**TOWN OF WINTER PARK
PLANNING COMMISSION
Tuesday, August 13, 2024 8:00 AM**

TO Planning Commission
FROM James Shockey, Community Development Director
DATE August 13, 2024
RE Minor Site Plan – Lot 1, Block 3, Roam Filing No. 1, 146 Exploration Trail (PLN24-059)

TO Planning Commission
FROM Brian P Kelly, Senior Planner
THROUGH James Shockey, AICP, Community Development Director
DATE August 08, 2024
RE Minor Site Plan – 285 Bridger Trail - Lot 8 Bridger’s Cache (PLN24-062)

1 ZONING - SITE PLAN
1/8" = 1'-0"

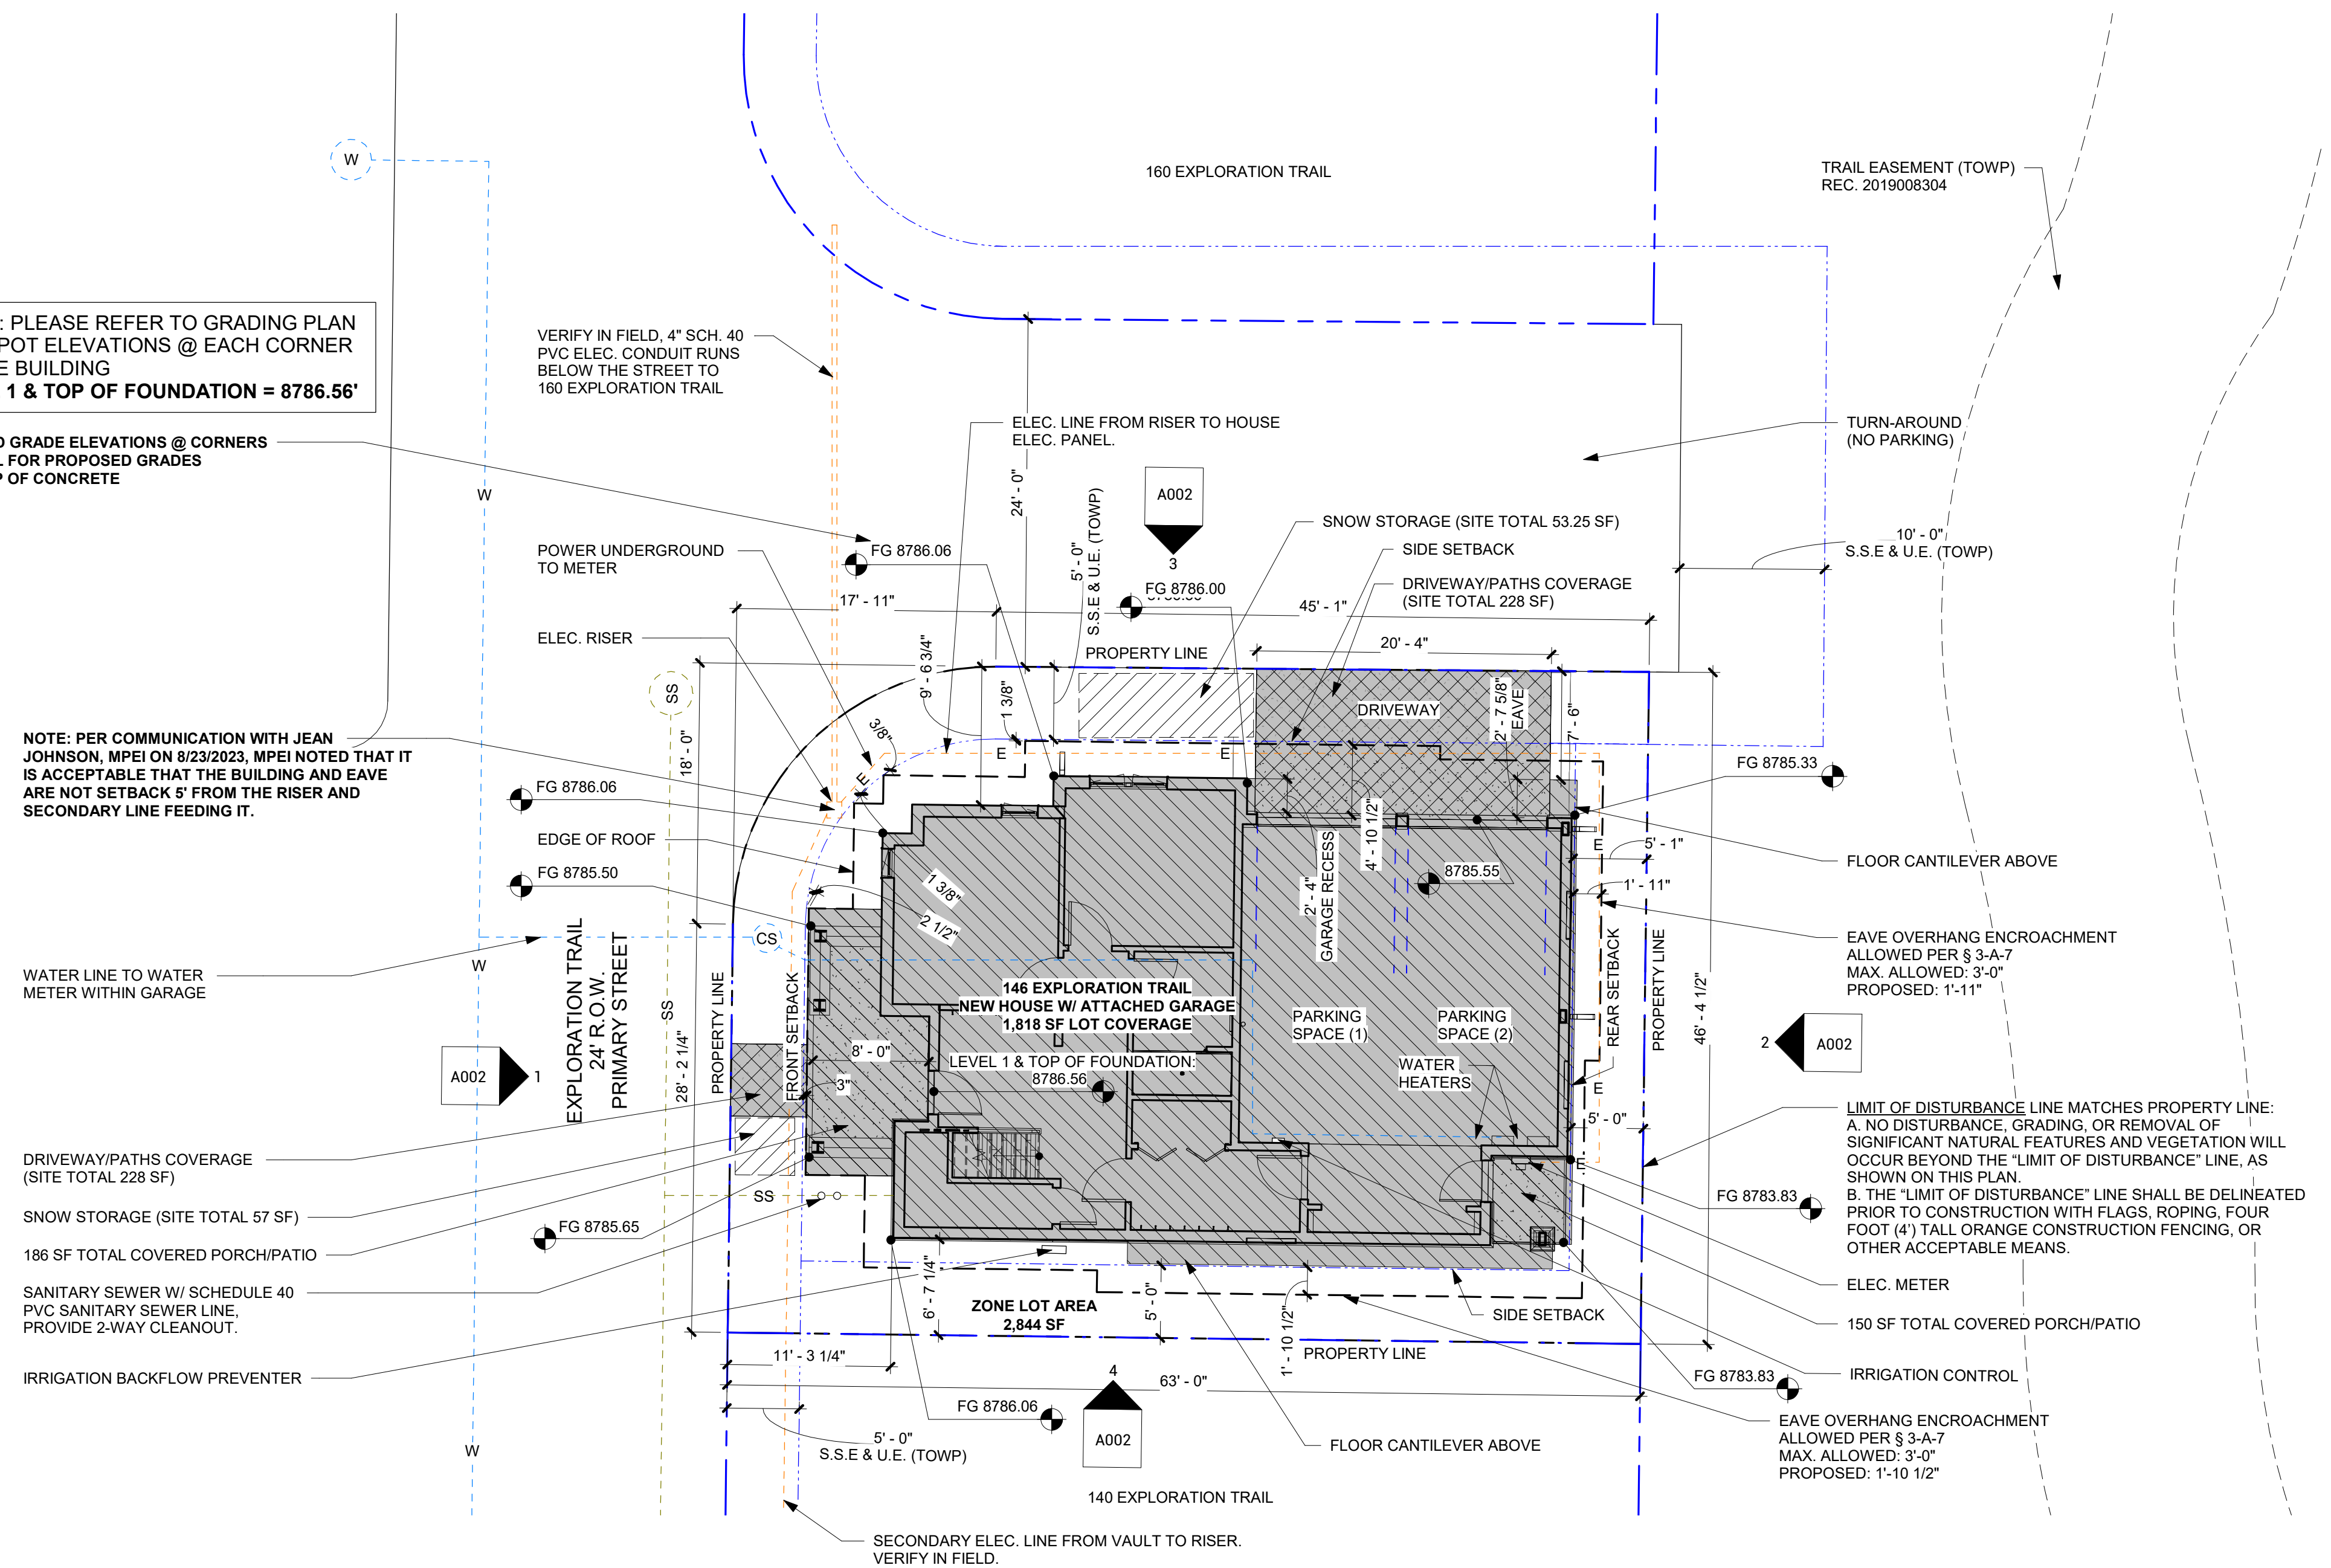
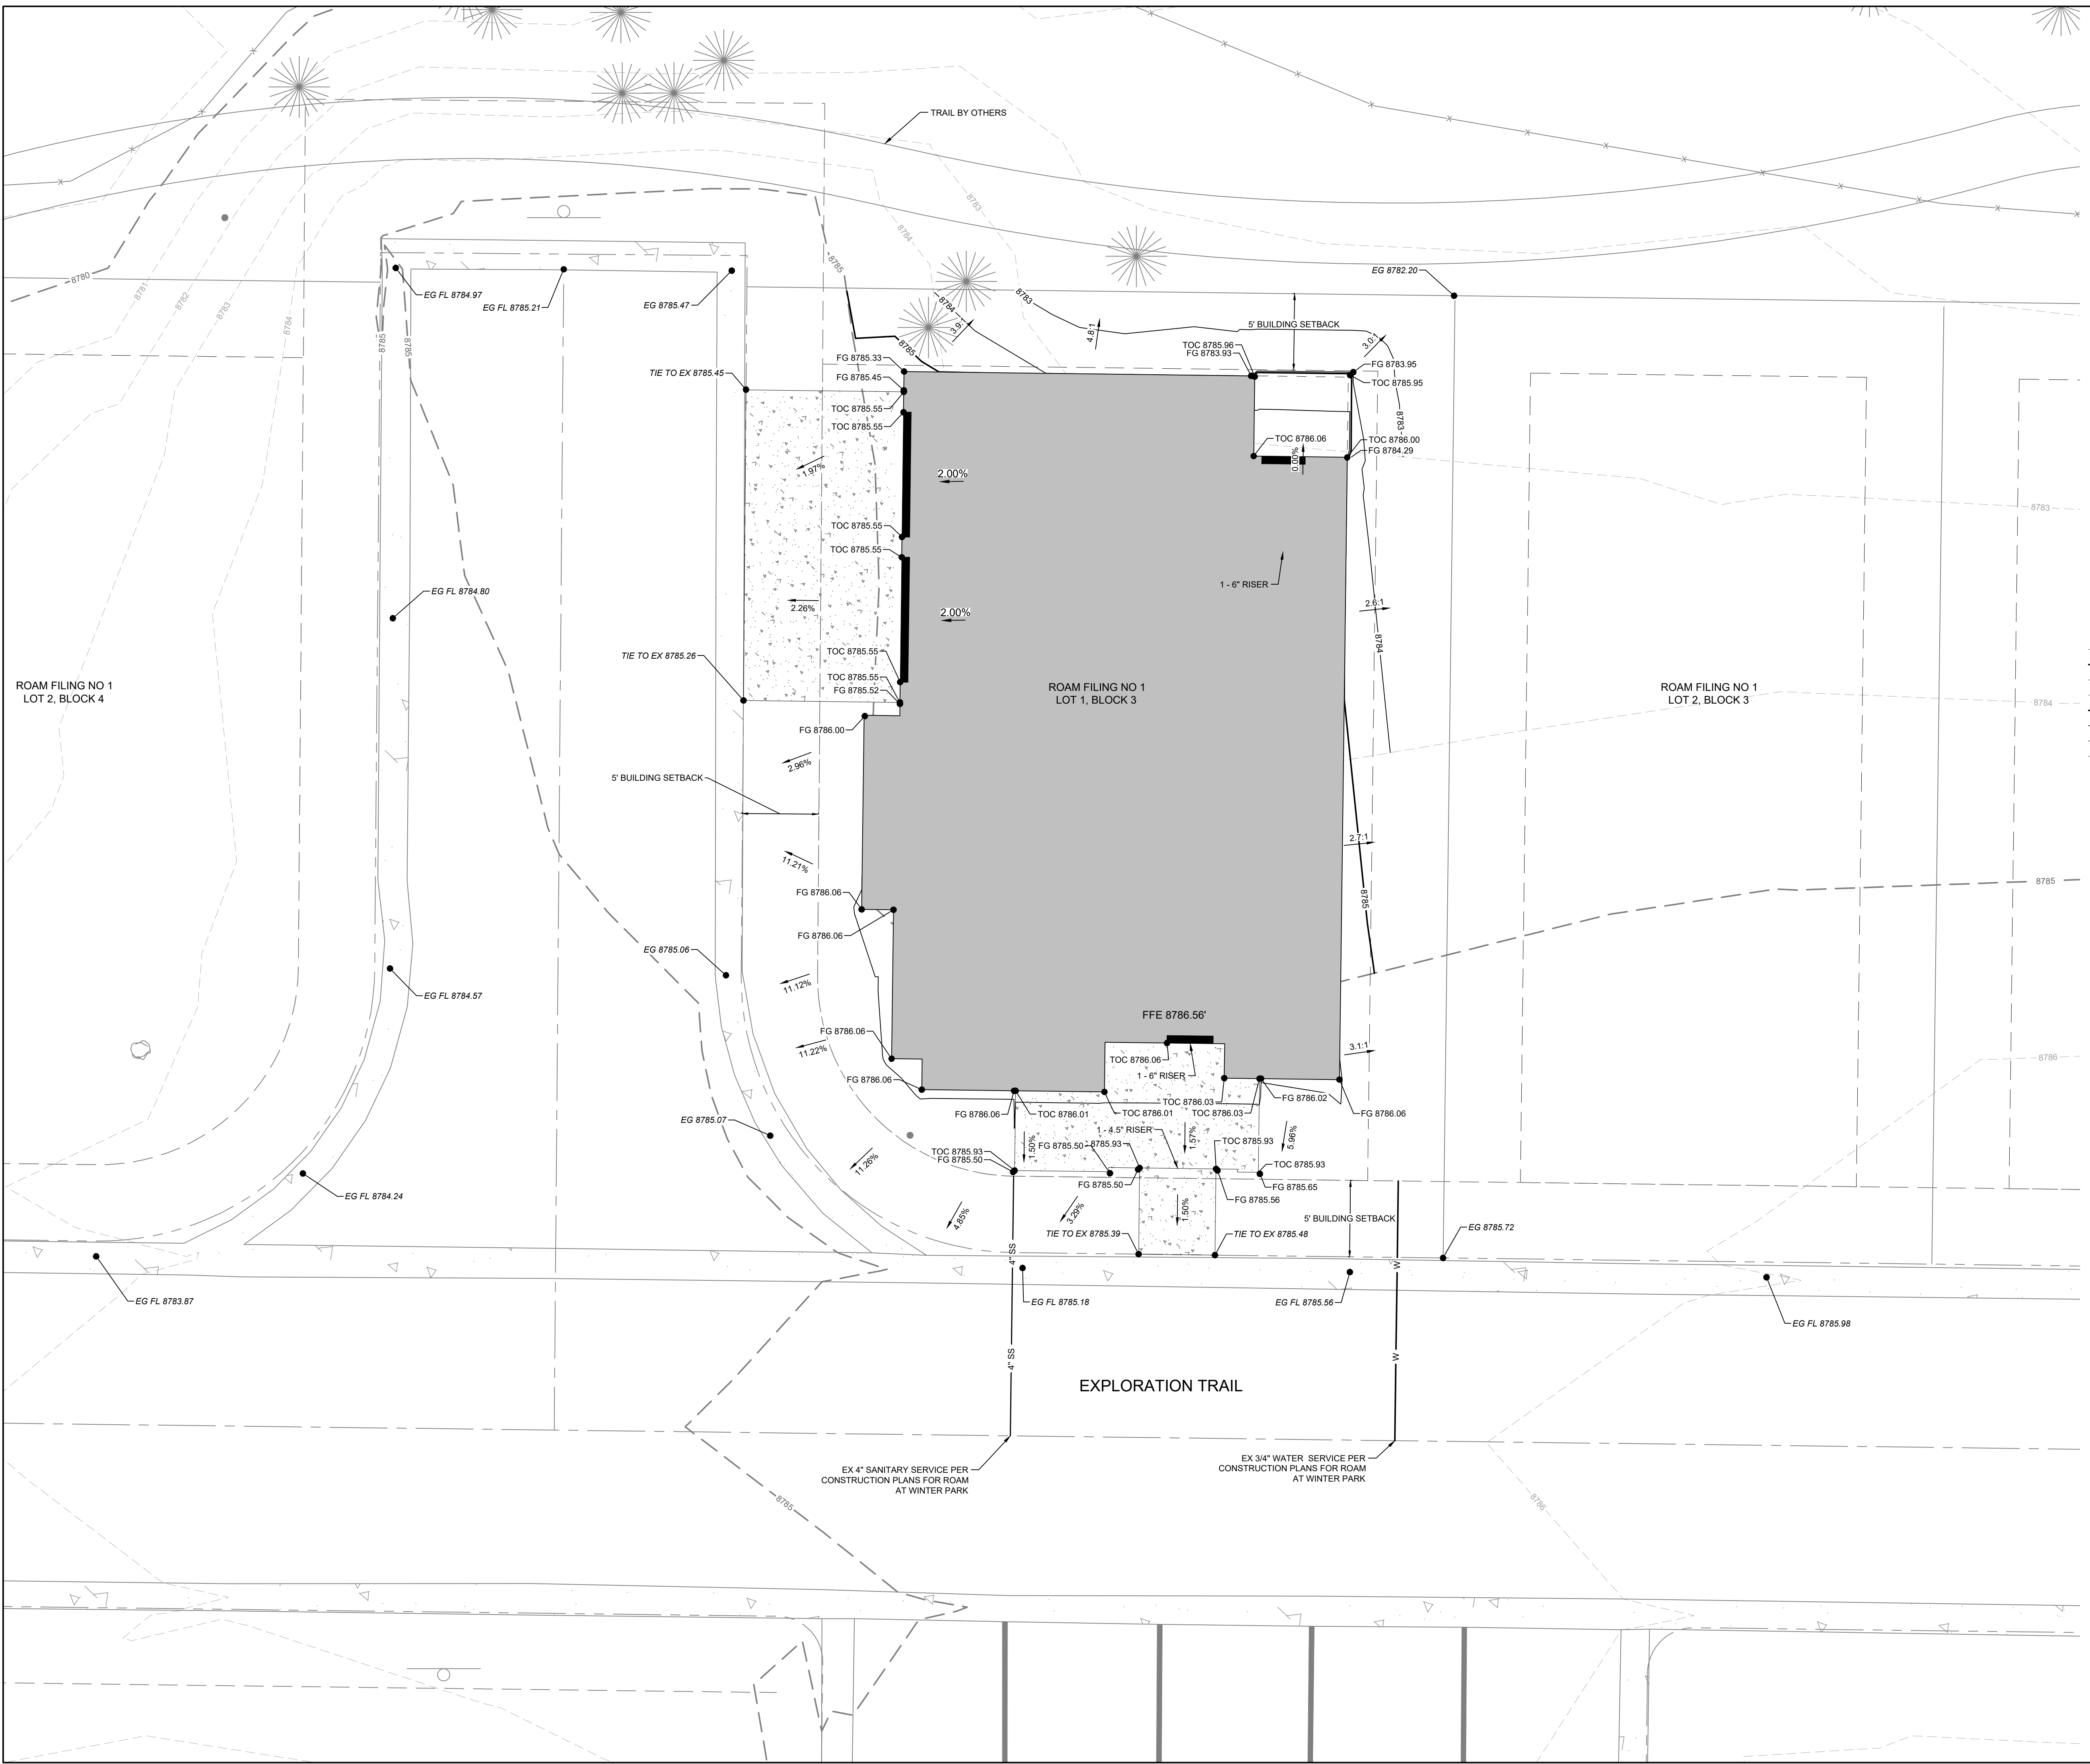
- Location of parking areas for construction workers' vehicles shall be indicated on a Site Plan exhibit.

- Applicant shall update the site plan exhibit to correct the error in snow storage site total adjacent to driveway.

6. Applicant shall provide a tree protection plan for the trees located just east of the property line.
7. The site plan shall be adjusted to come into conformance with Exhibit D, Note 3 of the Second Amendment to the Roam FDP.

BUILDING ELEVATIONS

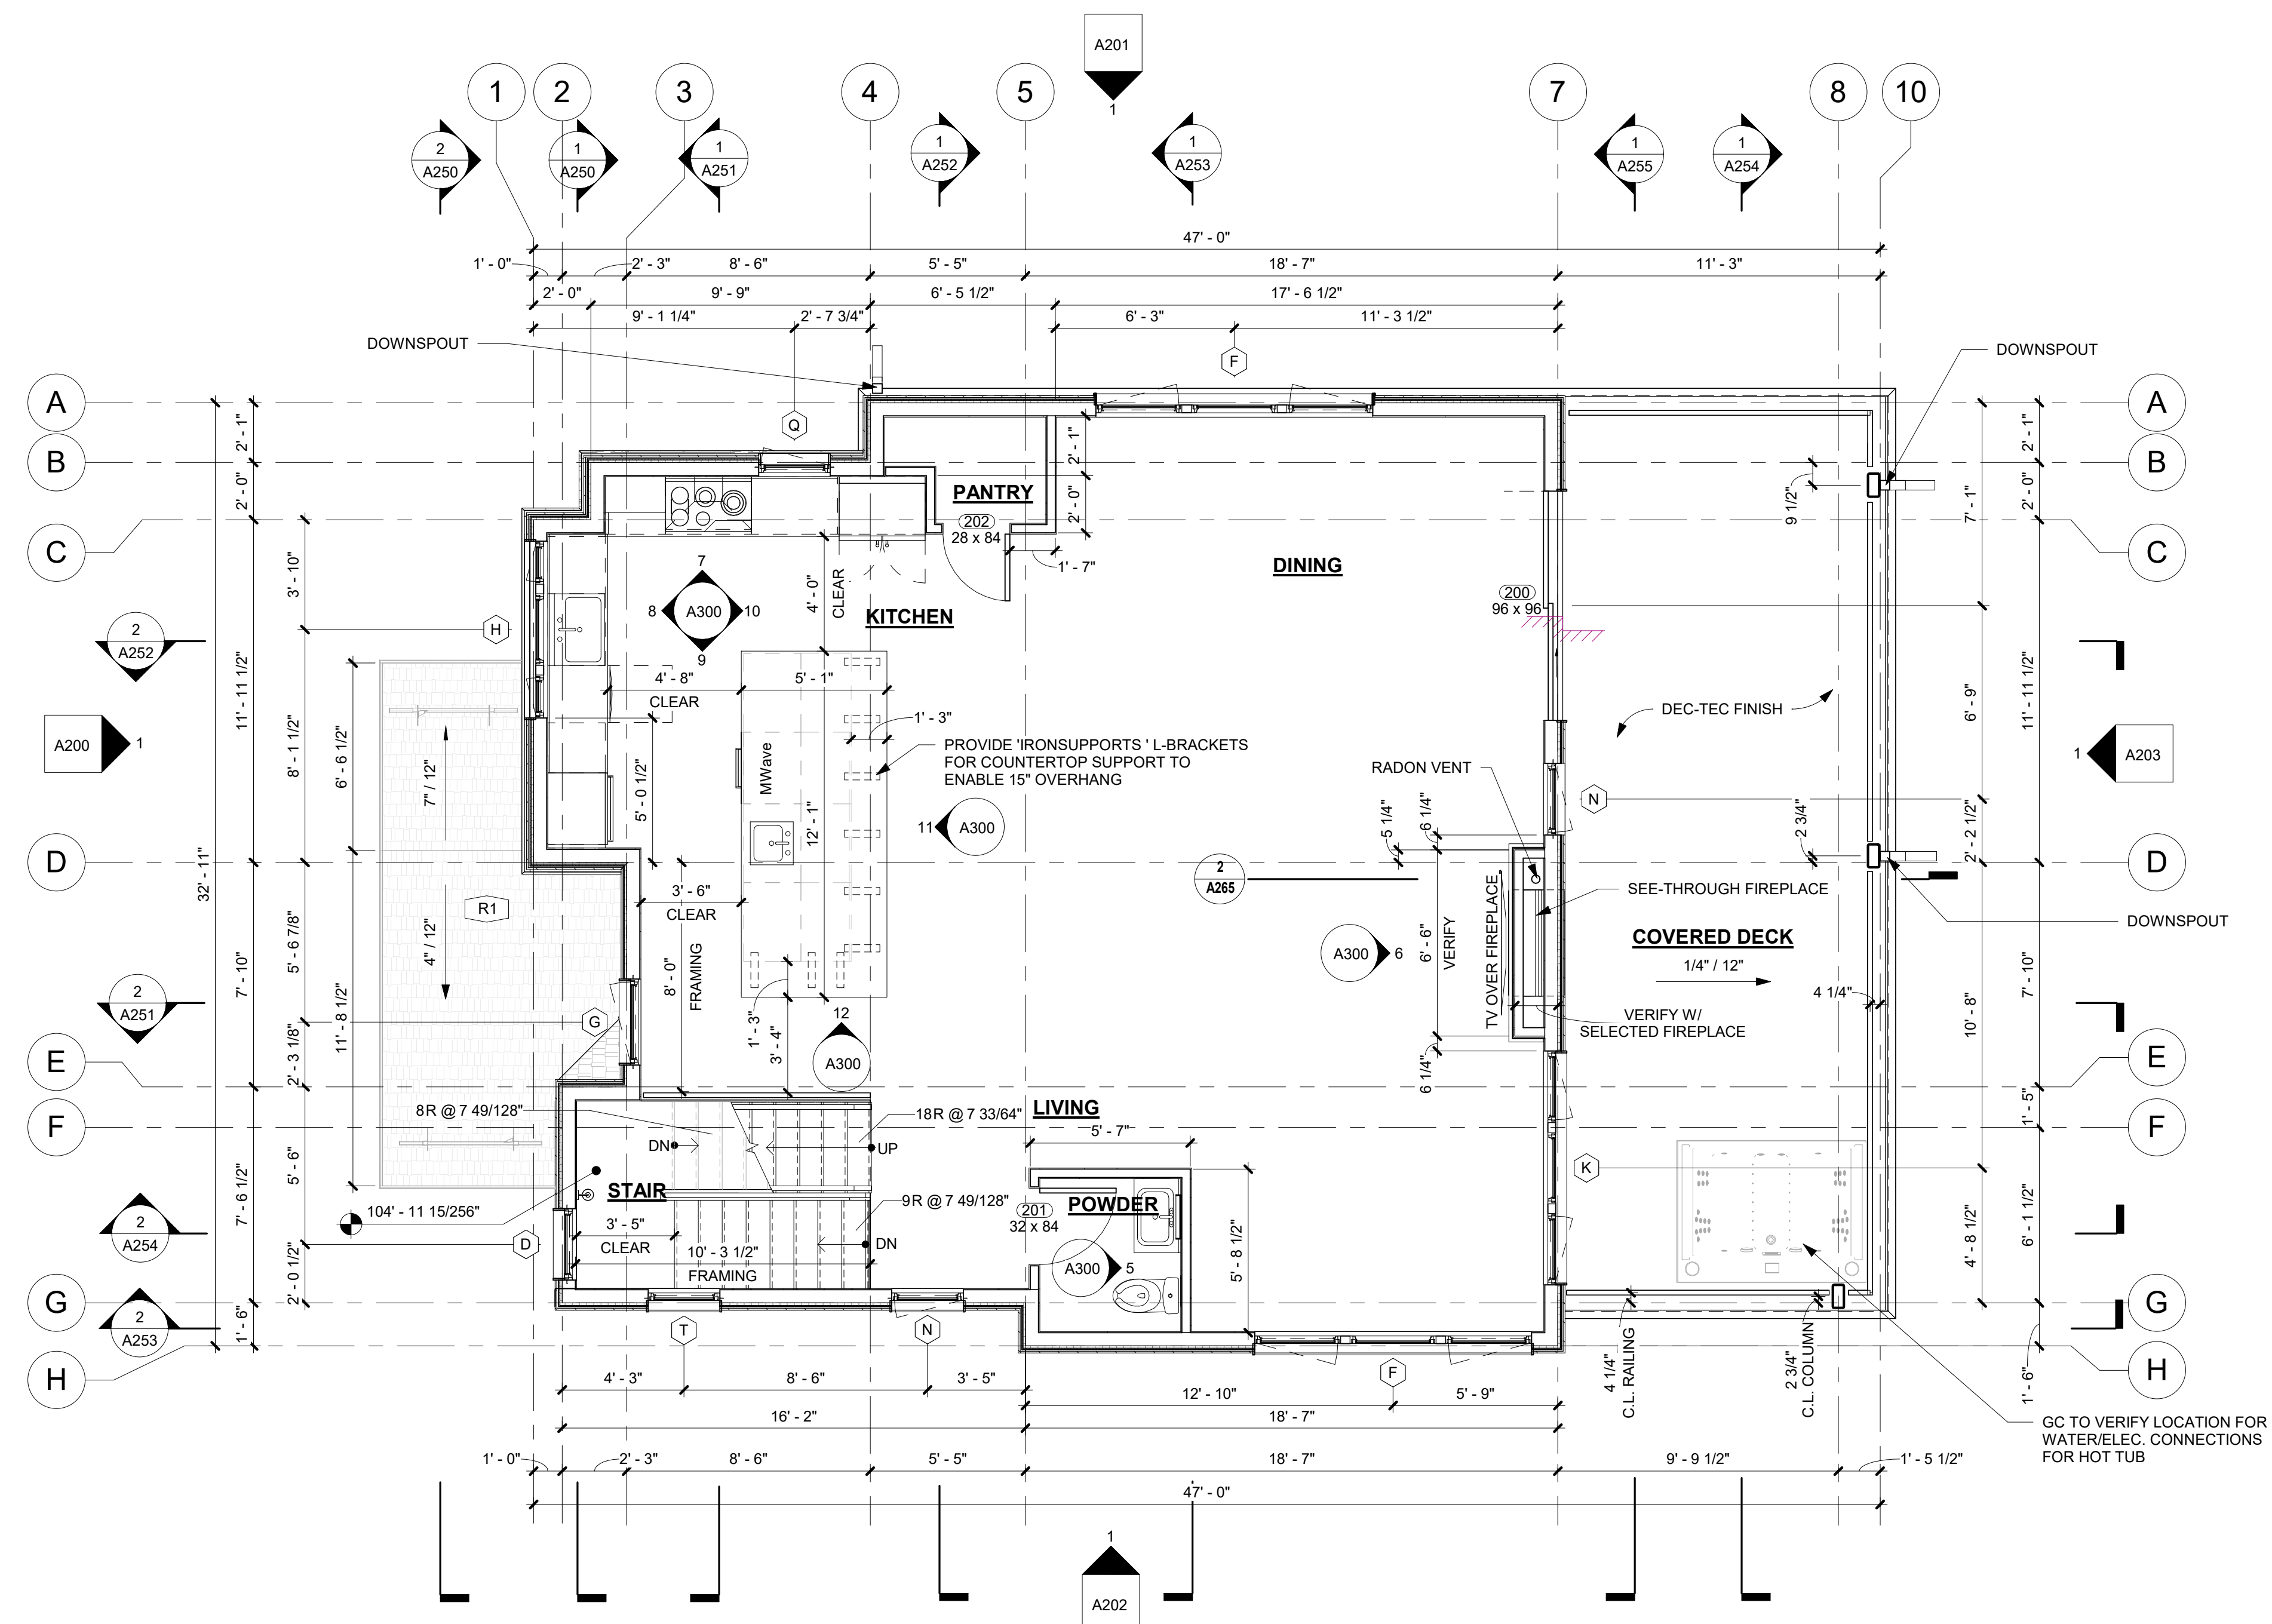
Partially satisfactory. Maximum building height in PA-1 is limited to 40' at pitched or hipped roof midpoint and the building measures at 40'. The proposed and existing grades are not labeled so staff can't verify where the height is being measured from.

4. Applicant shall label existing and proposed grades on the elevations.
5. Applicant shall update the site plan exhibit to correct the error in snow storage site total adjacent to driveway.
